# Access Compliance Report

## Public Rights-of-Way

Intersection ID: 14135	Main Street: CHESTERFIELD_AV	Cross Street: HANOVER_ST	Location: E
ADA ID: CD2E72996F87	Ramp Type: PerpDiag	Initial Pass/Fail: Fail	Overall Compliance: No
		Severity Score: 22.5

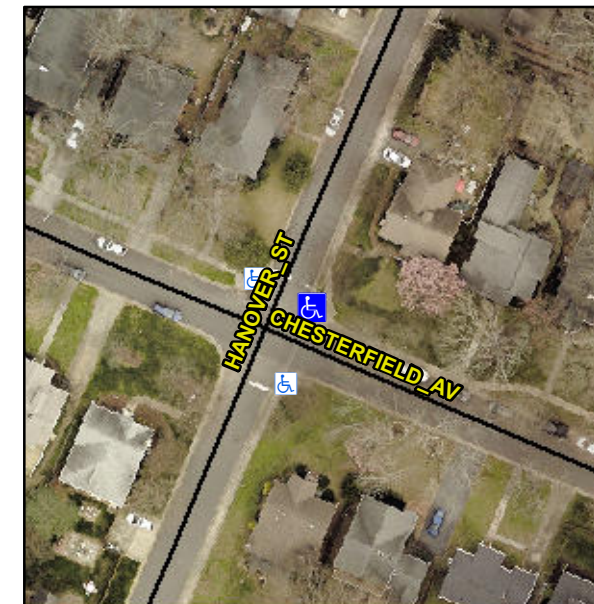
**Not Found, R304.5.1, R304.2.2, R304.5.3**

Compliance	Description	Data	Compliance	Description	Data
N/A	Ramp Length (in)	59.5	No	Ramp Slope (%)	9.0
No	Ramp Width (in)	41.0	No	Ramp XSlope (%)	4.3
N/A	Flare Type LT	N/A	N/A	Flare Type RT	N/A
N/A	Flare Slope LT (%)	N/A	N/A	Flare Slope RT (%)	N/A
N/A	Flare Traversable LT?	N/A	N/A	Flare Traversable RT?	N/A
N/A	Landing Length (in)	N/A	N/A	DWS Provided?	N/A
N/A	Landing Width (in)	N/A	N/A	DWS Contrast?	N/A
N/A	Landing Slope (%)	N/A	N/A	DWS Length (in)	N/A
N/A	Landing X Slope (%)	N/A	N/A	DWS Full Width?	N/A
N/A	Landing Curb? (Y/N)	N/A	N/A	DWS Offset (in)	N/A
N/A	Shared Landing?	N/A			
N/A	Gutter Ponding?	Yes	N/A	Gutter Slope (%)	N/A
N/A	Gutter Lip Ht (in)	1.5	N/A	Gutter X Slope (%)	N/A
N/A	Painted X Walk1?	No	N/A	Painted X Walk2?	No
	X Walk 1 Direction	To NW		X Walk 2 Direction	To SW
N/A	X Walk 1 Width (in)	N/A	N/A	X Walk 2 Width (in)	N/A
	X Walk 1 Slope (%)	6.0		X Walk 2 Slope (%)	0.4
	X Walk 1 X Slope (%)	3.1		X Walk 2 X Slope (%)	3.0

**Remove & Replace Curb Ramp With Two New Directional Ramps or Equivalent.**
